Mercure Hotel Heathrow, UB3

DAS Addendum

FOR
London Borough of Hillingdon

REFERENCE
24009

2.1 Materials & Appearance

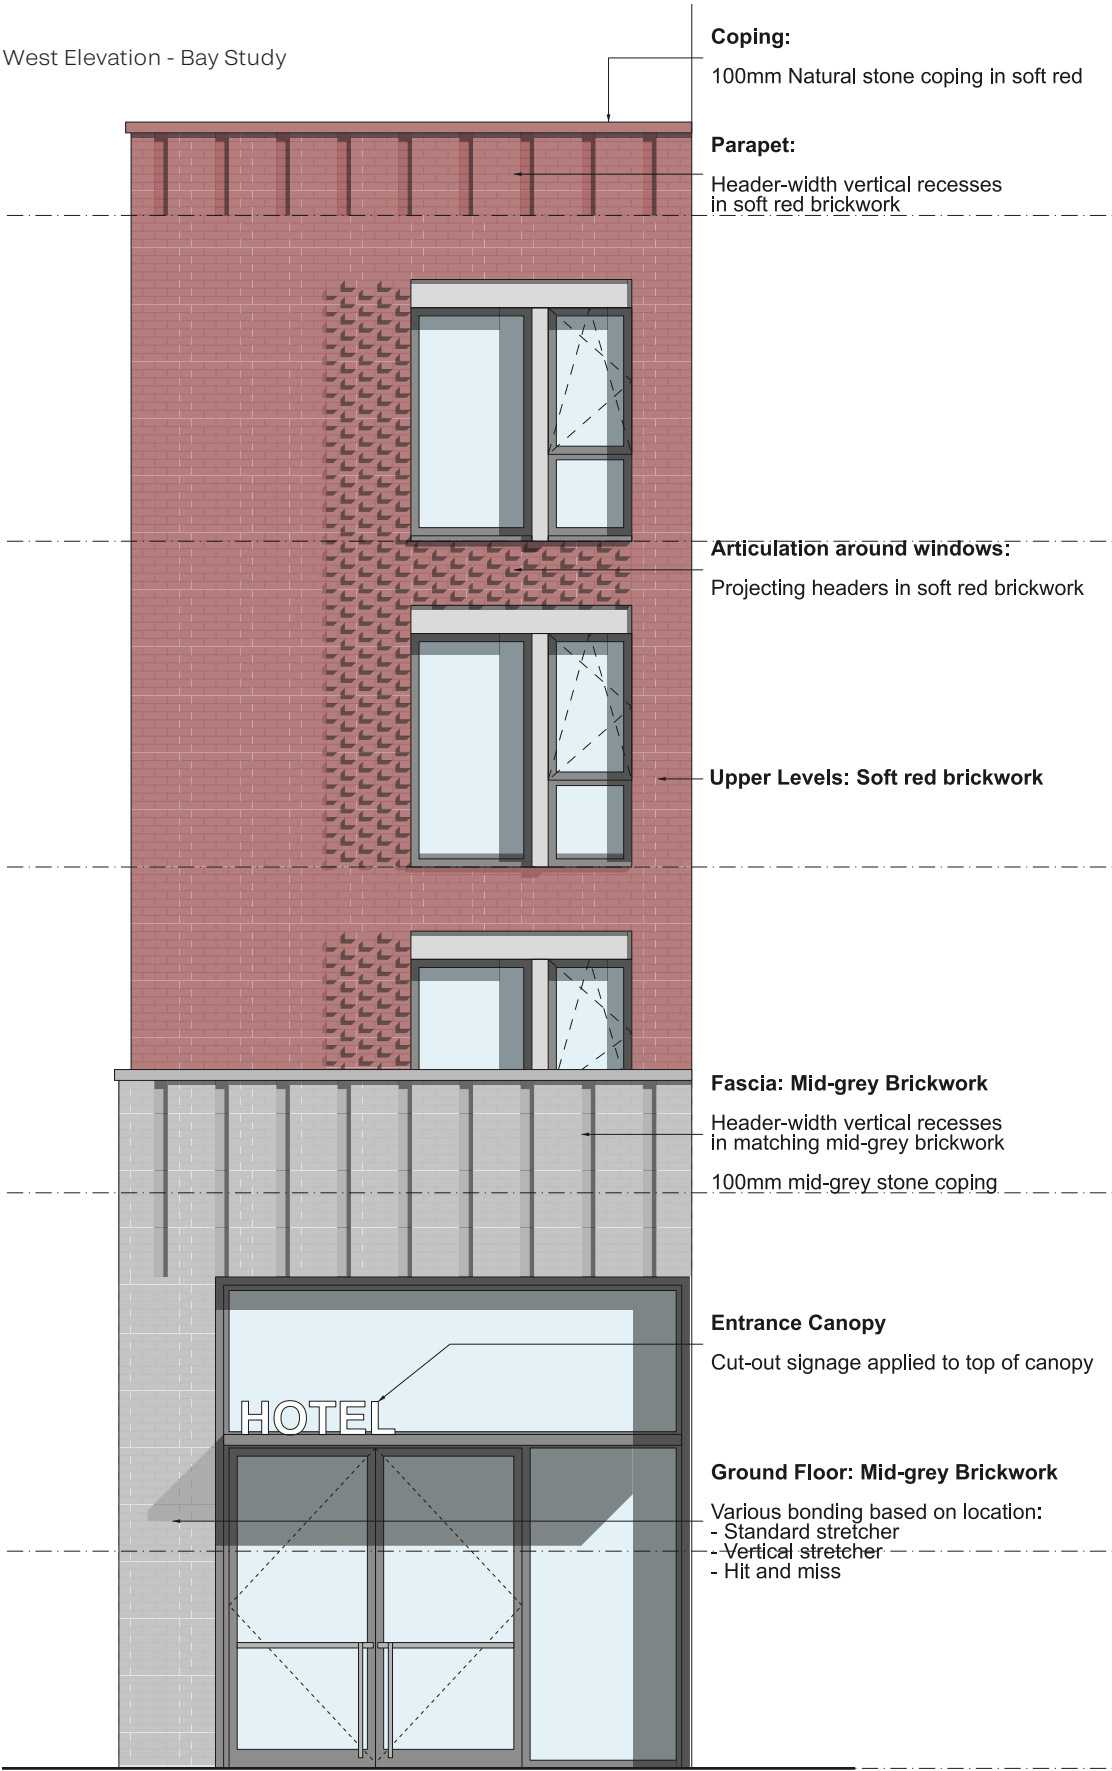
- Improve façade articulation: Reinstate more visual interest to avoid long, blank areas of brickwork, using features such as brick coursing, projecting brickwork, accent brick and selective vertical window grouping

- Clarify the cladding material: Resolve the inconsistency between the elevations (“mid-grey reconstituted stone”) and DAS (“mid-grey GeoBrick natural stone cladding”)
- Confirm the proposed cladding system: Provide the exact product/material and explain how the projecting forms shown in the CGIs will be achieved with the proposed cladding system

Parapet Detail:
The recessed vertical slot detail at parapet level responds directly to the Design Officer’s comments and provides a simple means of introducing additional articulation to the roofline.

The slots are formed within the same brickwork as the surrounding façade, maintaining a consistent material treatment while creating changes in depth and shadow across the parapet.

Articulation Around Windows:
Projecting brickwork has been introduced around window openings to reinforce the vertical rhythm of the elevations and provide additional depth and shadow.

The detail provides visual variation throughout the day as changing sunlight conditions emphasise the projecting masonry, while avoiding the introduction of additional façade materials.

Ground Floor Fascia:
The previously proposed mid-grey GeoBrick natural stone cladding has been replaced with mid-grey brickwork of standard metric dimensions. This provides a more consistent relationship with the principal soft red brickwork and allows the revised projecting and recessed brickwork details to be achieved using a coherent masonry palette.

The ground-floor fascia will adopt the same architectural language as the upper parapet treatment, expressed at a greater height and formed in mid-grey brickwork. This provides a visual connection between the building’s plinth, ground floor and upper elevations.

Stone copings will be used to complete the parapet and wall-head details. The stone will be selected in colours complementary to the adjacent brickwork and will project approximately 50mm beyond the brick face to provide robust weather protection.

2.2 Updated View Towards Arlington Court

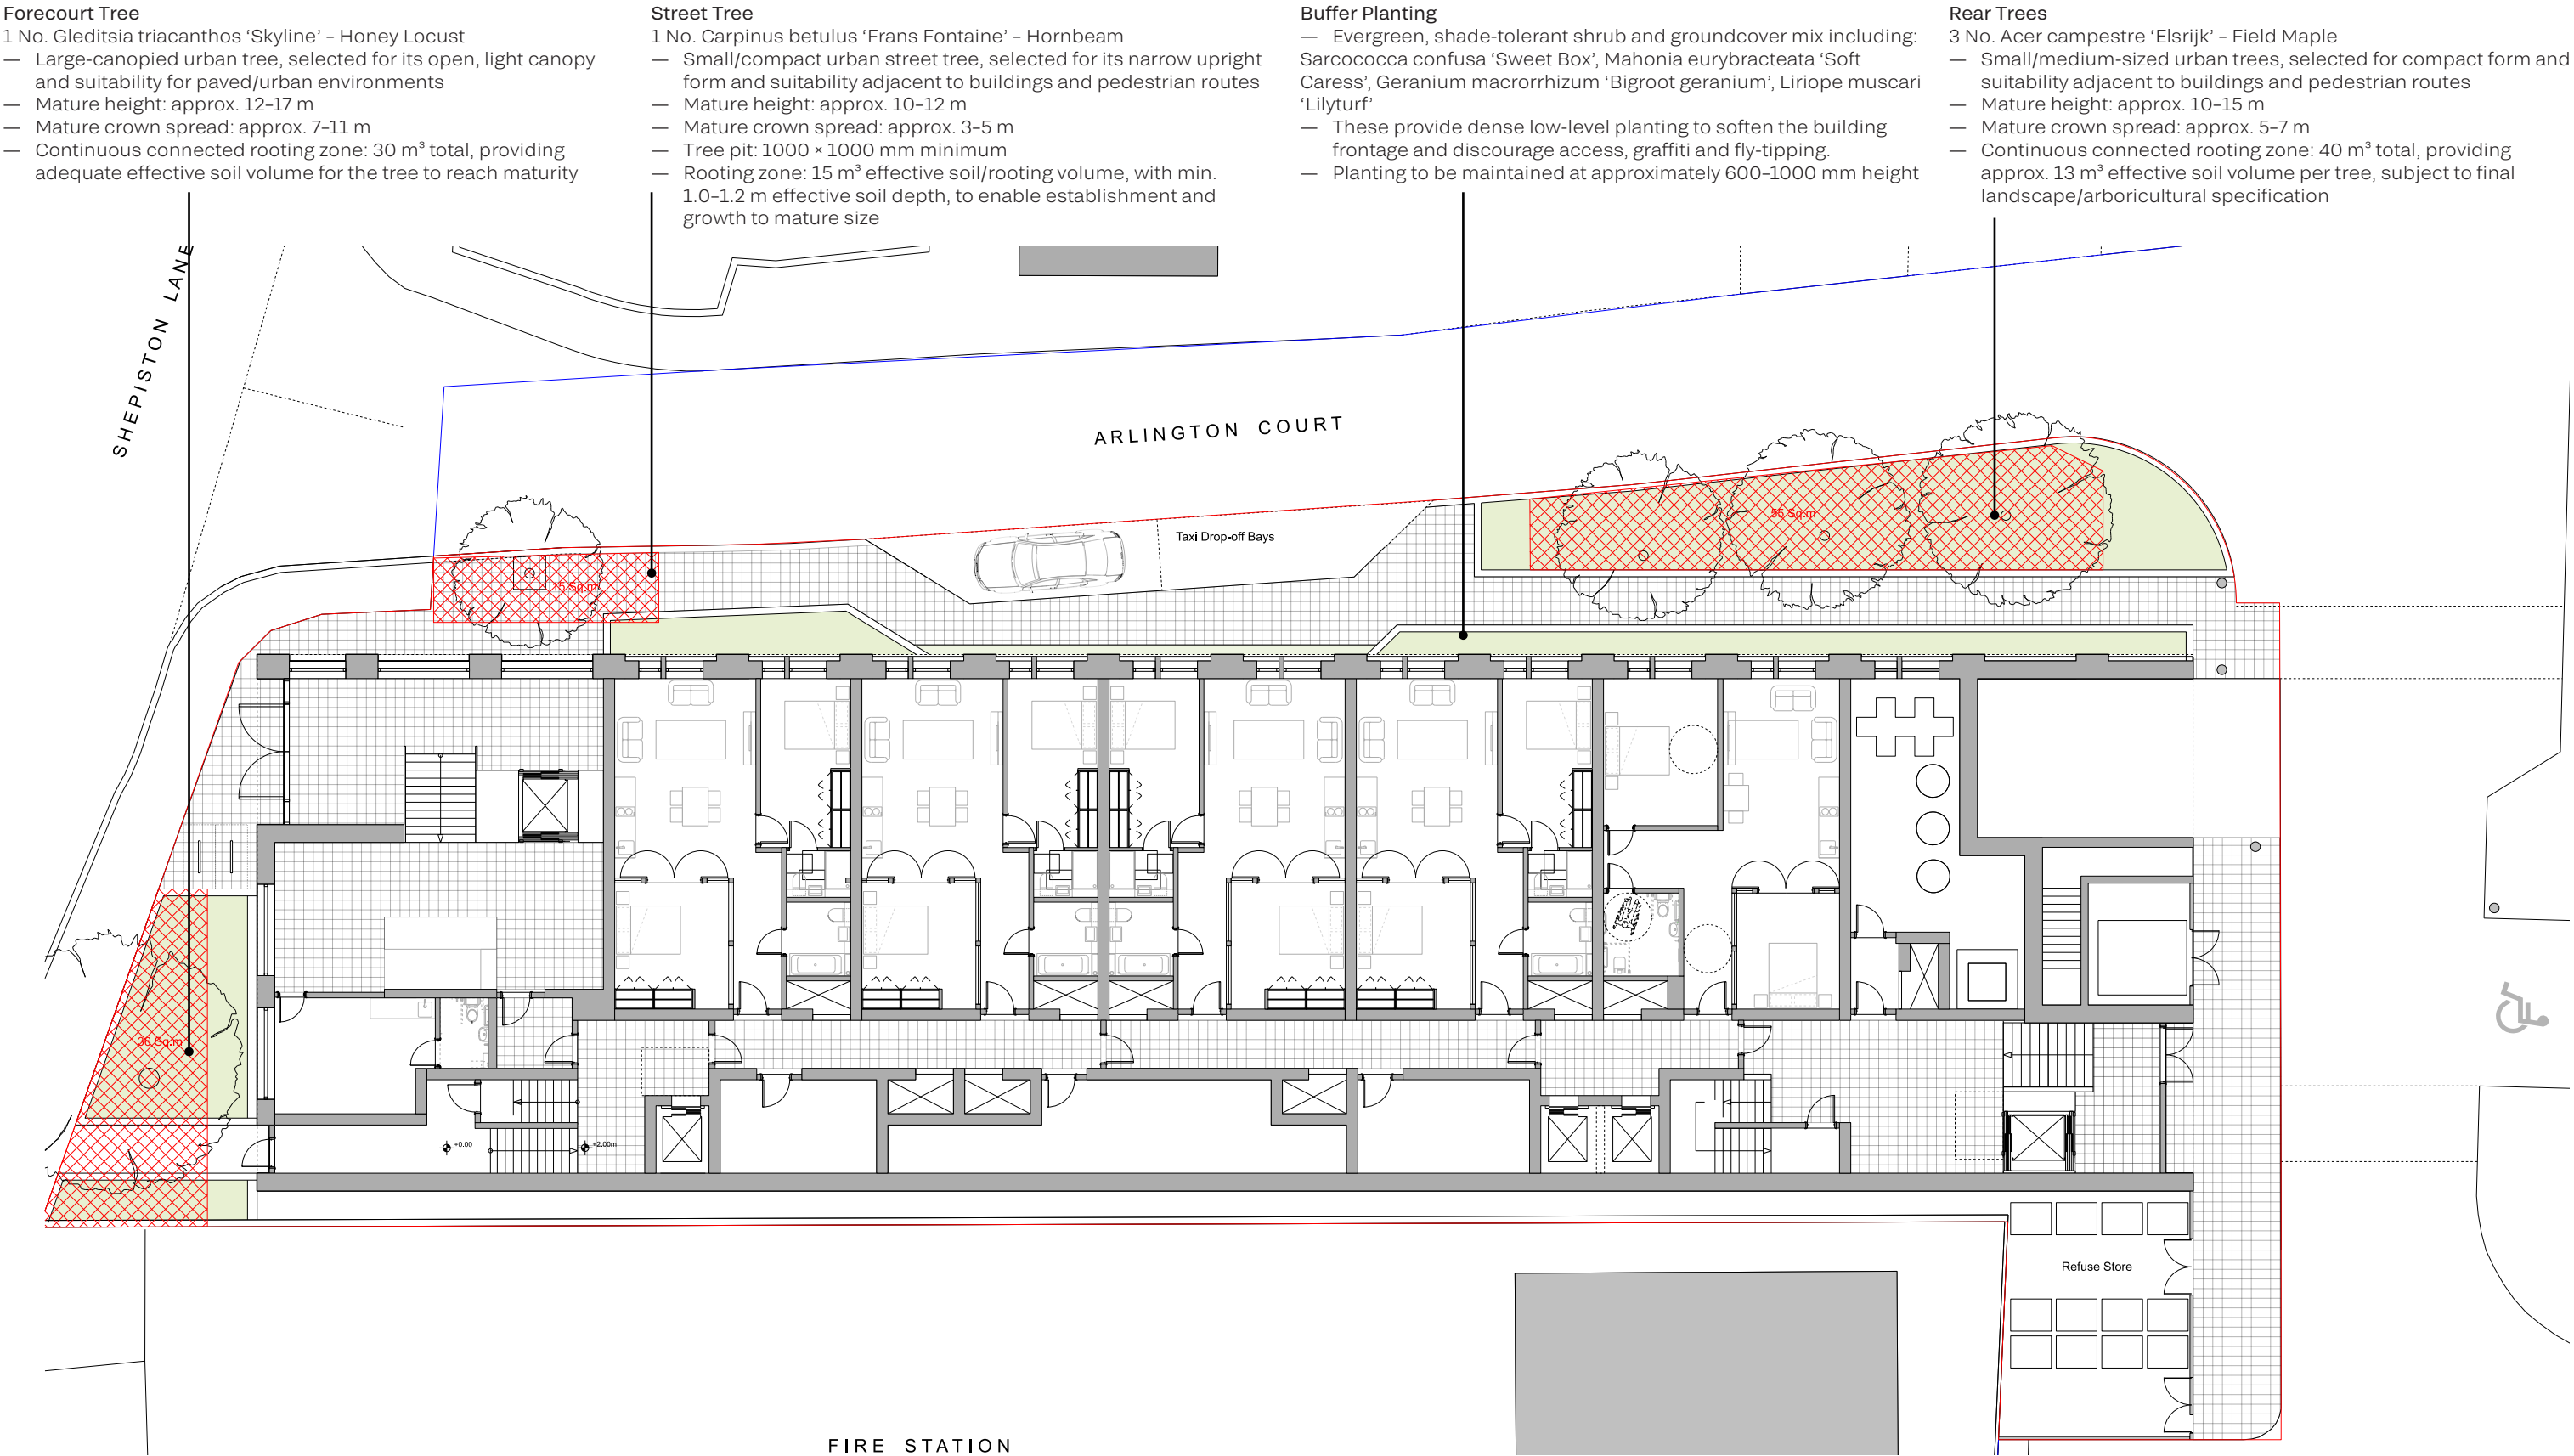
- Add planting along Arlington Court: Introduce low-level/linear planting along the façade to soften the building frontage and the basement vent areas
- Demonstrate street-tree delivery: Show how the proposed street trees can be accommodated and grow to maturity, including underground infrastructure/soil provision

- Improve the ground-floor frontage: Retain the proposed hit-and-miss brickwork to the basement vents and add buffer planting to soften the raised/blank frontage
- Consider Juliet balconies: Add Juliet balconies to ground-floor windows facing Arlington Court, with screening/opacity to improve privacy and the appearance of the frontage

The updated view demonstrates the revised treatment to the Arlington Court frontage, including the additional buffer planting, ground-floor treatment and façade articulation.

The landscaping and architectural elements shown in the view have been coordinated with the updated proposals shown overleaf.

2.4 South Elevation

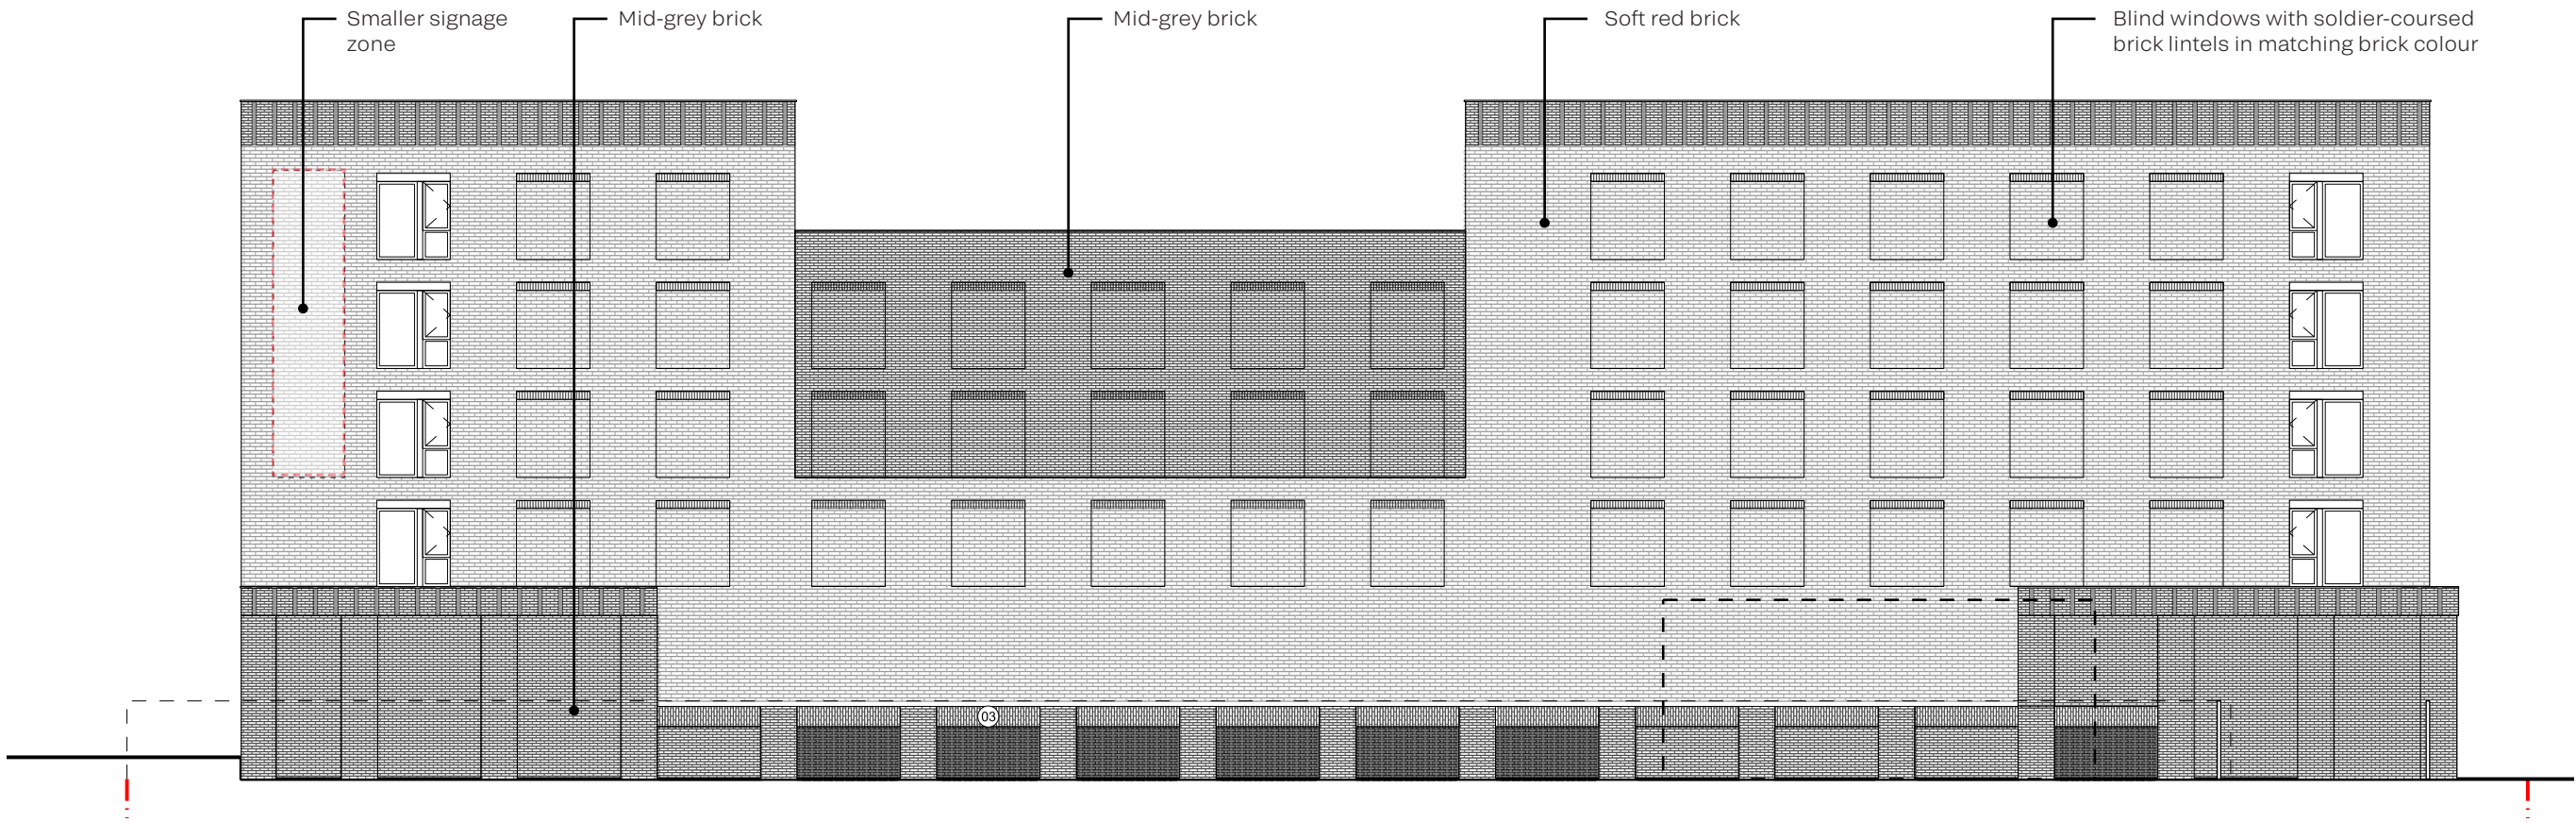
- Improve the south elevation: Add architectural articulation to the south façade so it is not perceived as a large, blank brick wall
- Provide a south-elevation CGI: Show the building from Shepiston Lane and ensure this elevation is represented to the same standard as the other key views
- Reduce south-side signage: Reduce the size/area of the signage on the south elevation

The south elevation has been further articulated to strengthen its architectural expression and break up the overall expanse of brickwork through the following measures:

- Increased use of the contrasting mid-grey brick to introduce greater variation and articulation across the façade and reinforce the building's overall massing.
- Reduced signage zone to minimise its visual impact on the elevation
- Introduction of blind windows aligned with the grid of the northern elevation, with consistent expressed lintels in soldier-course brickwork to reinforce the architectural rhythm and coherence of the façade
- Consistent parapet and coping treatment matching the detail used across the remainder of the building, providing a unified architectural language

The south elevation is approx. 1.0 - 1.2m away from the boundary.
